AMENDED NOTICE OF DISAPPROVAL

Date: March 4, 2021

PLEASE TAKE NOTICE that your application dated December 24, 2020 – with required documents received on January 7, 2021 - to make alterations to a 2-story building and an accessory structure at 511 Carpenter Street - is returned herewith and disapproved on the following grounds:

Date: Scale:
Drawing Title: AS NOTED
SITE PLAN

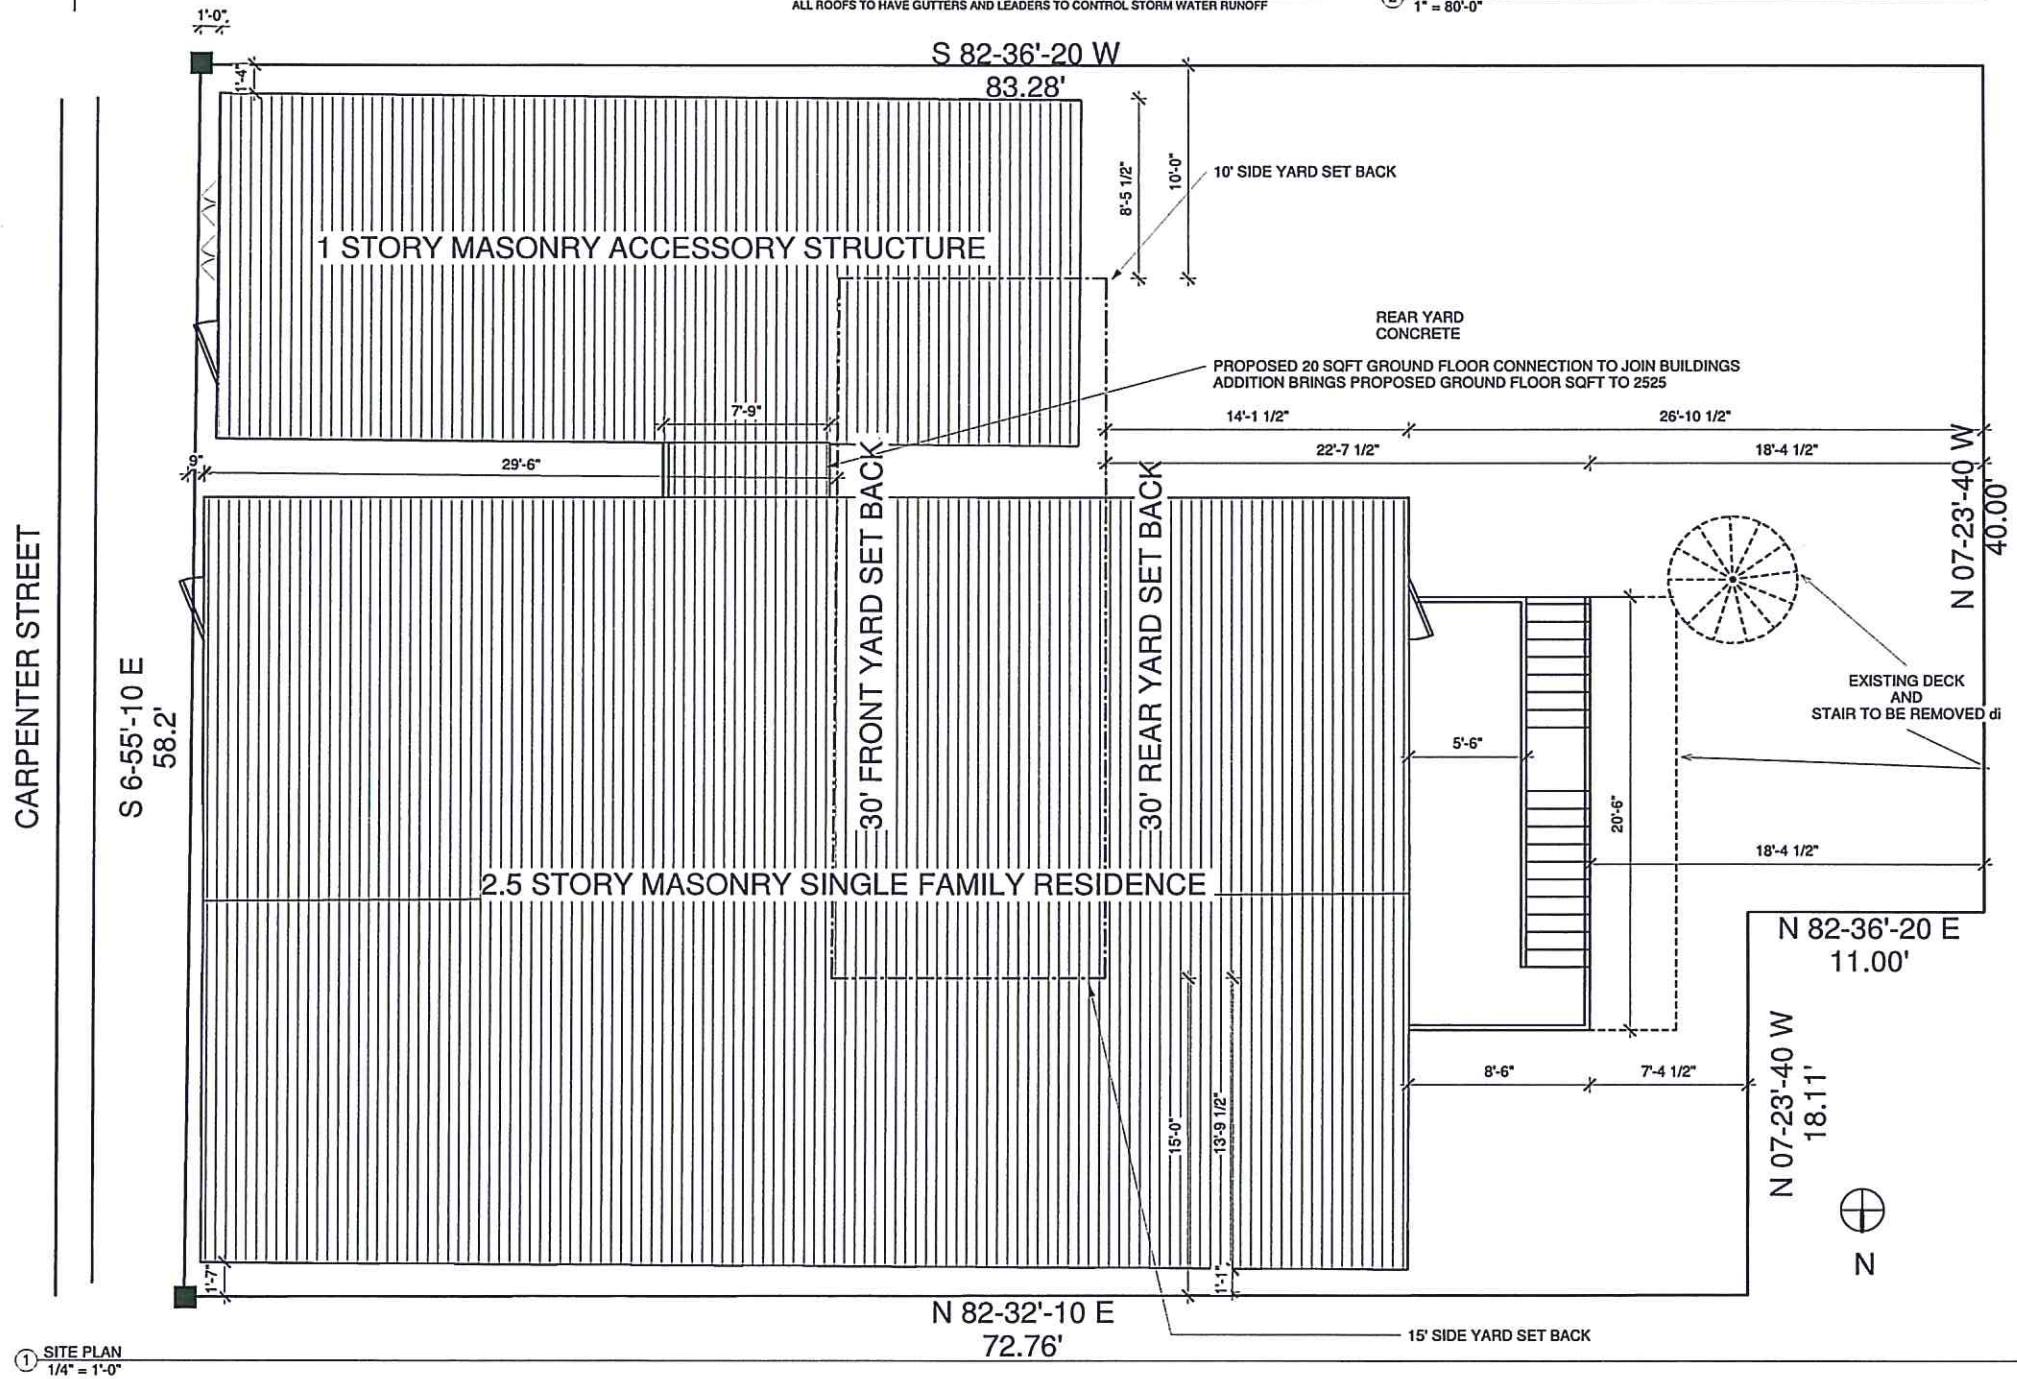
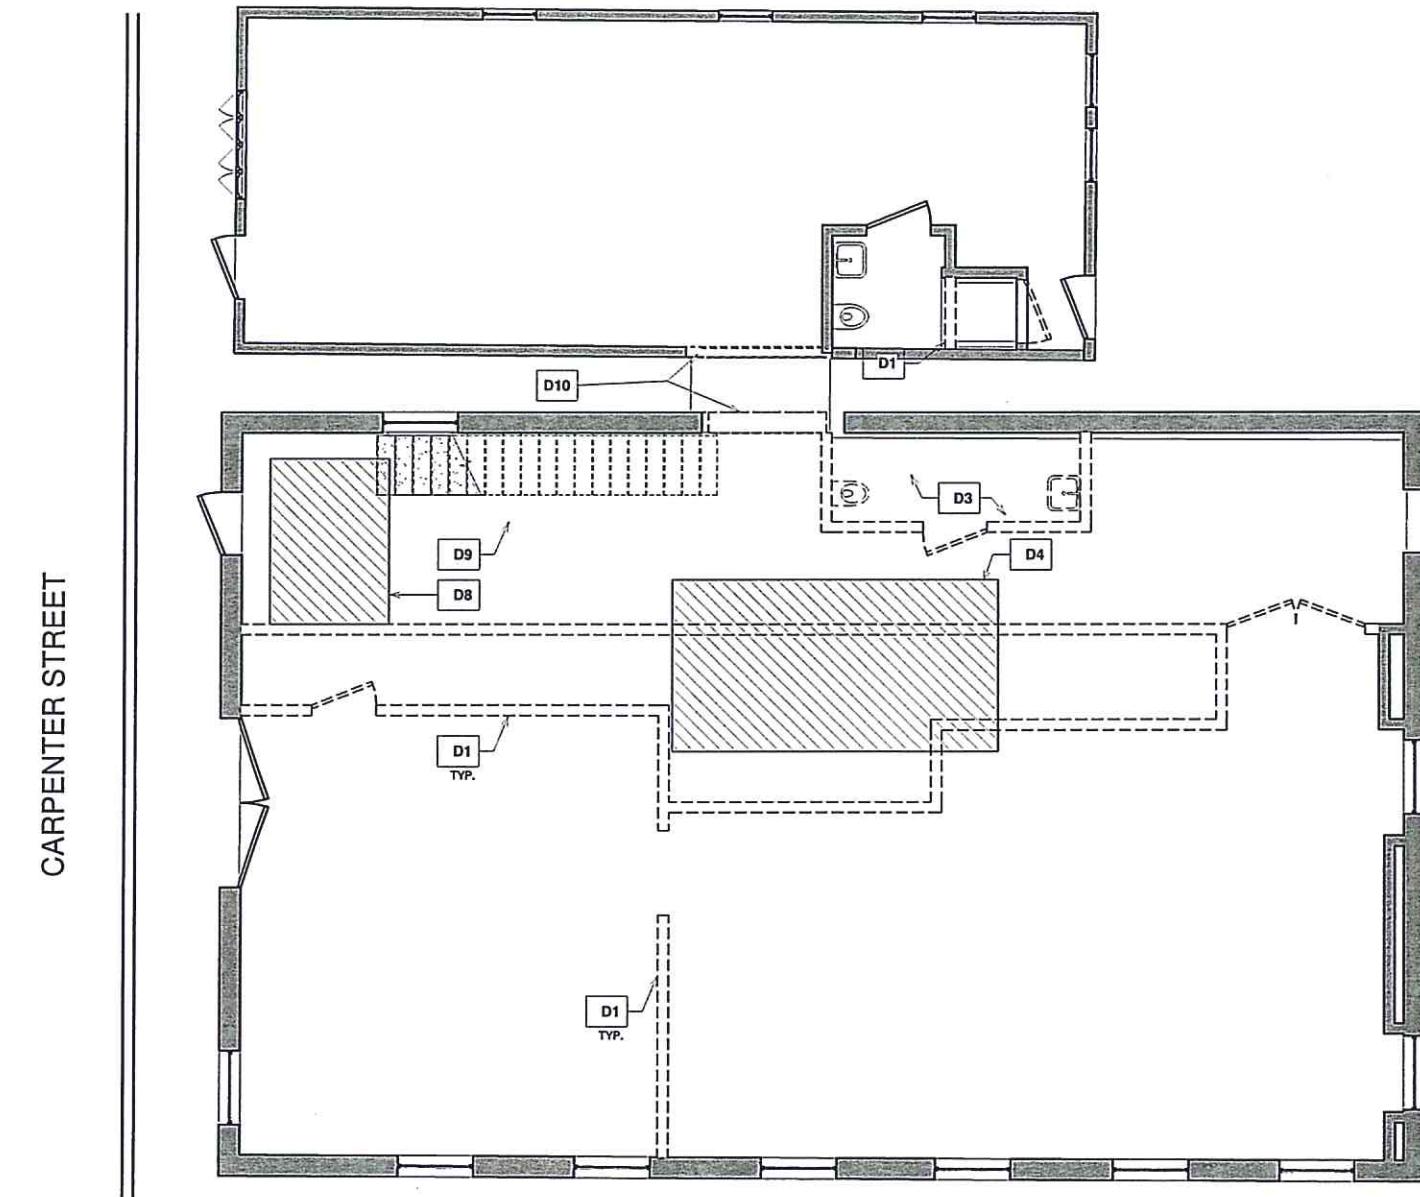
The specifications show the proposed lot coverage is 2,525 SF (52%). The allowable lot coverage is 1,437 SF (30%) This would require an area variance of 1,088 SF (22%) lot coverage increase.

The plans show the front yard of the 2-story building setback of 1-feet, 6-inches. This would require an area variance of 28-feet, 6-inches.

The plans show the front yard setback of 1-feet, 6-inches. This would require an area variance of 8-feet, 6-inches.

The plans show the front yard setback of 1-feet, 6-inches on the north side. And 3-feet, 4-inches on the south side. this would require an area variance of 20-feet, 4-inches.

The plans show the front yard setback of 5-feet, 6-inches. This would require an area variance of 24-feet, 6-inches.
